FCC Radio Test Report

Augmedics Ltd.

Radio Module

FCC ID: 2AR2O-VOB-P3310

Figure 1

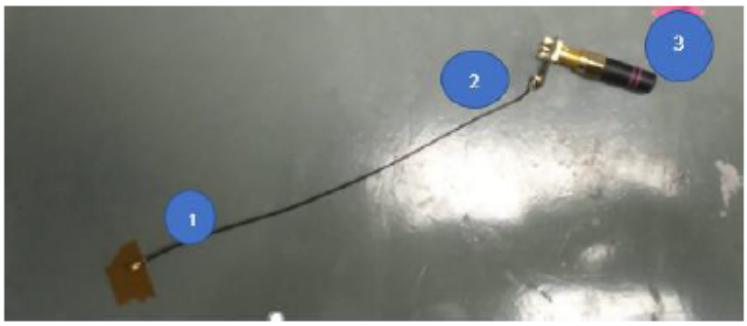
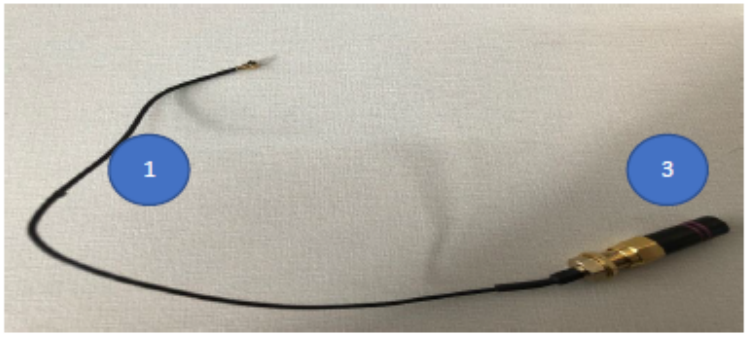
3. Additionally, on 7/2020 further C1PC changes were made:
   Replacing attenuator MNF PN AT0603T02ECATB (ATC) which was approved in pervious ITL Test Report No. E207760.01 with new attenuator MNF PN PAT1220-C-2DB-T5 (SUSUMO).
   As a result from that the PCB PCB00012 modified to PCB00012-2 due to the changes of the footprint AT1(-2db attenuator). For further information see ITL Test Report no. E216220.00. See Figure 1

4. Currently, the following C2PC changes have been made:
   Removing the PCB00012-2. As a result of that no -2dB Attenuator MNF PN PAT1220-C-2DB-T5 and replacing the cable form 415-0085-150 TO Hirose U. FL to SMA PN CB.720 (See Figure 2).

Previous Configuration According to ITL Report no: E216220.00- see figure 1			New Configuration according to ITL Report no: E224970.00- see figure 2		
Designator	Manufacturer	Manufacturer PN	Designator	Manufacturer	Manufacturer PN
PCB (2)	H.A Micro	PCB00012-2	No PCB		
Cable (1)	Cinch	415-0085-150 U. FL TO U. FL	Cable	TAOGLAS	CB.720 U. FL to SMA (1)
Antenna (3)	Linx	ANT-2.4-CW-RH	Antenna	Linx Technologies Inc.	ANT-2.4-CW-RHb (3)
AT1	American Technical Ceramics	AT0603T02ECATB	No Attenuator
